TITLE Specifications for the First CSP Building System.
INSTITUTION Detroit Public Schools, Mich.
SPONS AGENCY Detroit Board of Education, Mich.; Educational
Facilities Labs., Inc., New York, N.Y.
PUB DATE 16 Nov 70
NOTE 230p.
EDRS PRICE MF-\$0.65 HC-\$9.87
DESCRIPTORS Architects; Architectural Elements; Bids; *Component
Building Systems; Construction Management; Contracts;
Controlled Environment; Critical Path Method;
Facility Requirements; Fast Track Scheduling; Legal
Responsibility; Lighting; Planning (Facilities);
*School Construction; *Specifications; Structural
Building Systems; *Systems Approach
IDENTIFIERS *Construction Systems Program

CONSTRUCTION
SYSTEMS PROGRAM

DETROIT PUBLIC SCHOOLS — CONSTRUCTION SYSTEMS PROGRAM
Sub Systems Scheduling Guidelines

December 21, 1970

**SHERRARD SCHOOL ADDITION
for School Housing Division
Board of Education
Detroit, Michigan**

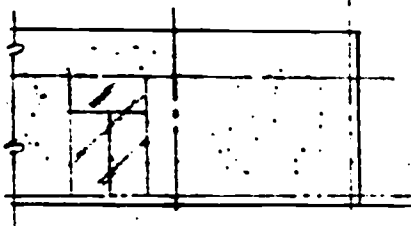
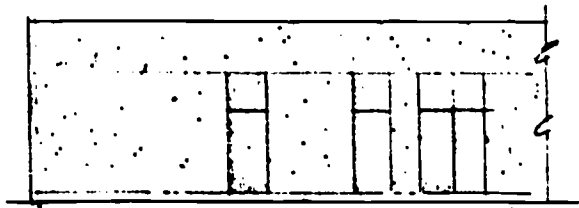
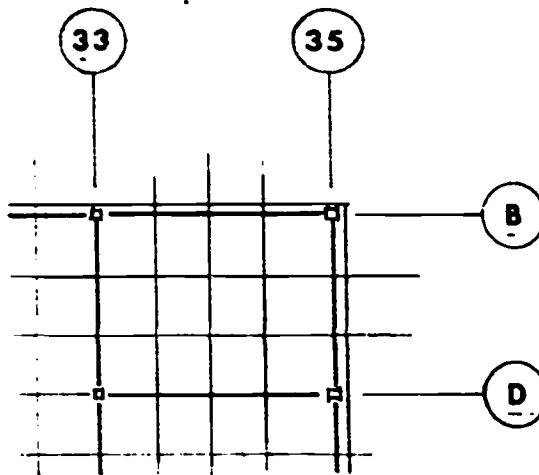
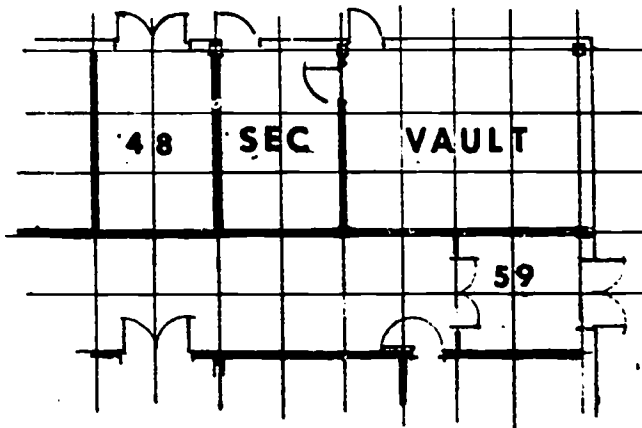
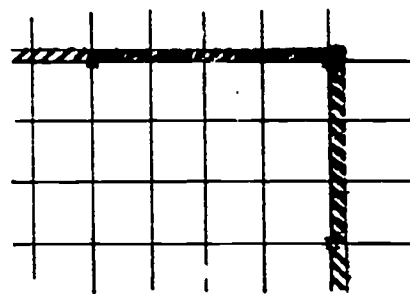
- A3.1 Page 3, Drawing List - SHERRARD SCHOOL ADDITION. Add drawing on Page No. A3-8 with revised plan layout and changes indicated to drawings previously issued as follows: ST-1, ID-1, VS-1 and VS-2.
